Lombardo & Associates  
comment prior to May 28,  
2025 Planning Commission  
Hearing.  
-HCD-Planning

RE: Johnson/PLN210061

Re: Johnson Hal W Jr. & Allison H; File No. PLN210061; May 28, 2025 Monterey County Planning Commission, Agenda Item No. 2.

Re: Response to Peer Review Comments for  
Proposed Development at 226 Highway 1  
Carmel Highlands, California  
Monterey County APN 241-182-003

## Photographs

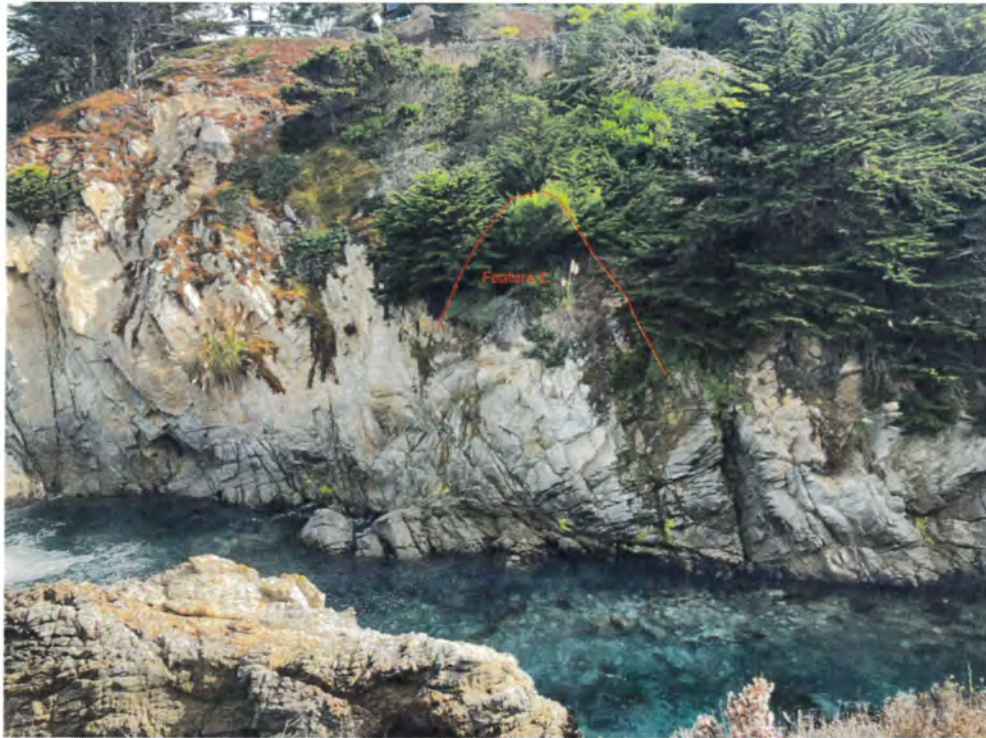
Easton Geology Response: Feature "B", as delineated by the reviewer, is located below the joint-bounded scarp mapped by our firm. Formation of the joint-bounded scarp appears to be the

Easton Geology Response: We do not believe that Feature "C", as delineated by the reviewer, corresponds with any mapped slope instability features mapped by our firm. The location of "Feature C" on the photo markup by the reviewer lies in the northernmost portion of the parcel, is coincident with a shallow drainage swale, and appears to be 60 or more feet from any proposed improvements. The joint-bounded headscarp referenced on our geologic map was discussed above and corresponds with Feature "B" delineated by the reviewer.

result of a wedge failure within the weathered granite on the upper bluff. We measured two adversely dipping joint sets in this area, and their resulting line of intersection (the axis of sliding) trends 228AZ and plunges approximately 47 degrees to the southwest. The upslope trend of the axis of sliding passes well north of the proposed residence. Current revised plans for the project depict the proposed residence about 30 feet from the left margin of the mapped wedge failure scarp depicted on Plate 1 of our report and is at least 40 feet from the axis of sliding. The footprint of the proposed residence and its foundation will not be affected by potential enlargement of this slide feature. We saw no wedge failures of similar or larger size during our investigation.

**Figure 5 Project Elevation Profile**

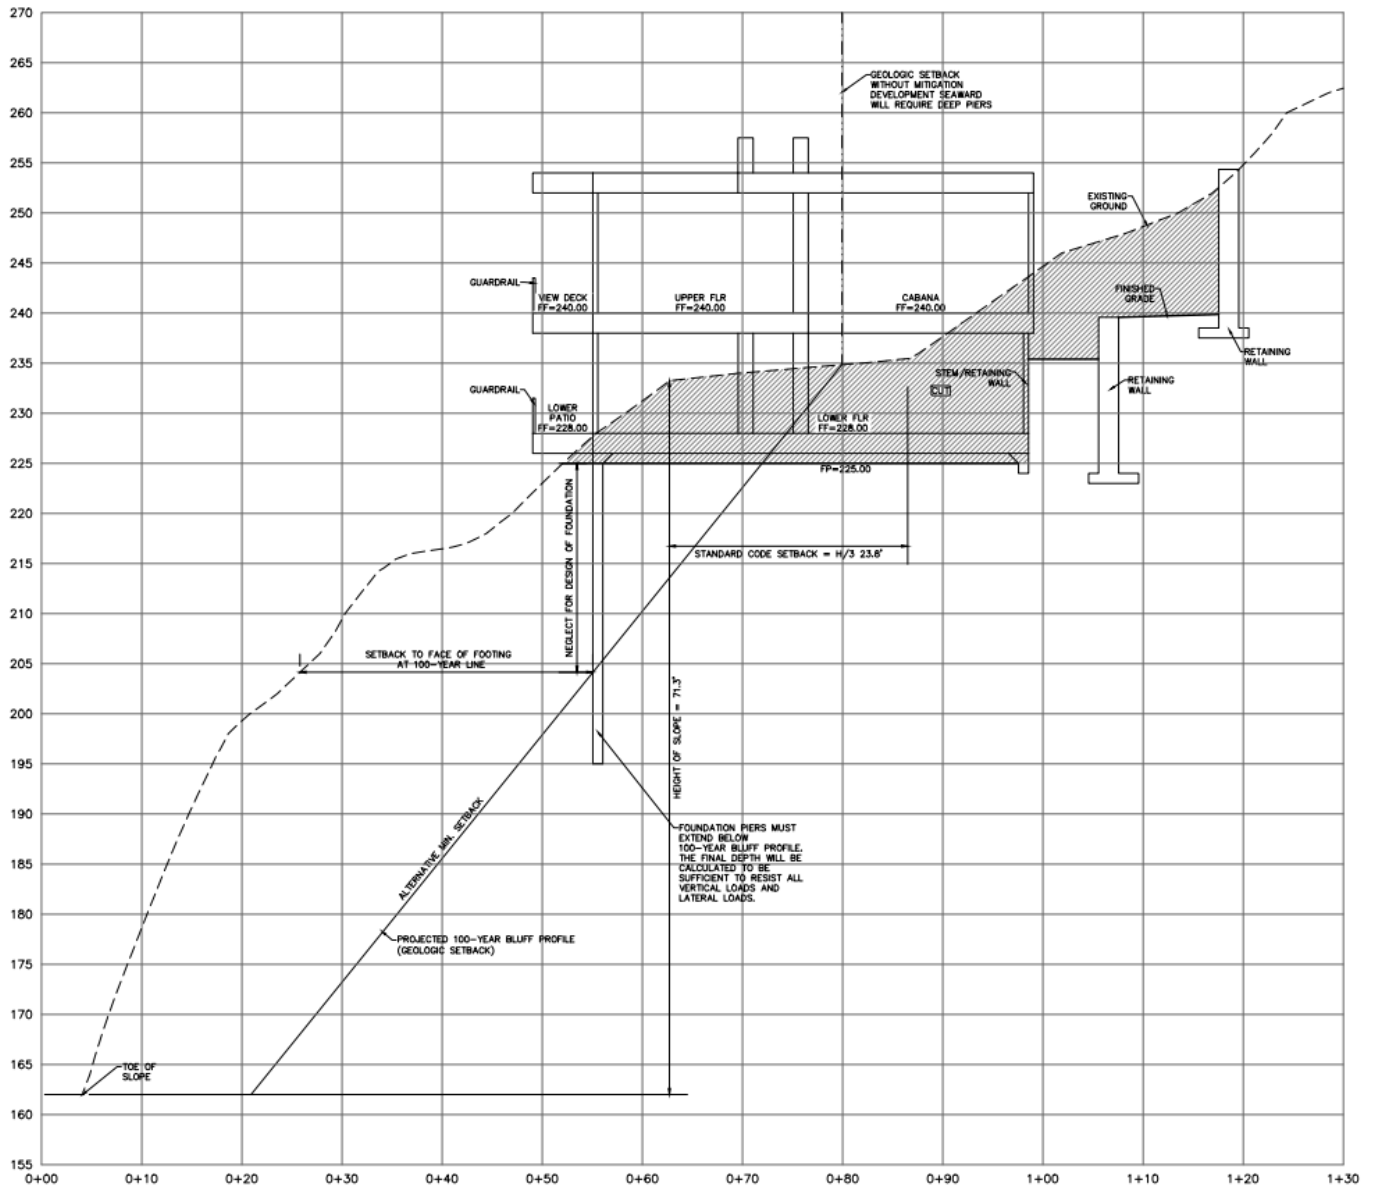
<sup>1</sup> Figure 5 (Project Elevation Profile) of the MND shows how the majority of the Project extends beyond the geologic setback line, protruding over the steep coastal cliff face. A copy of this figure is attached hereto as Exhibit A.
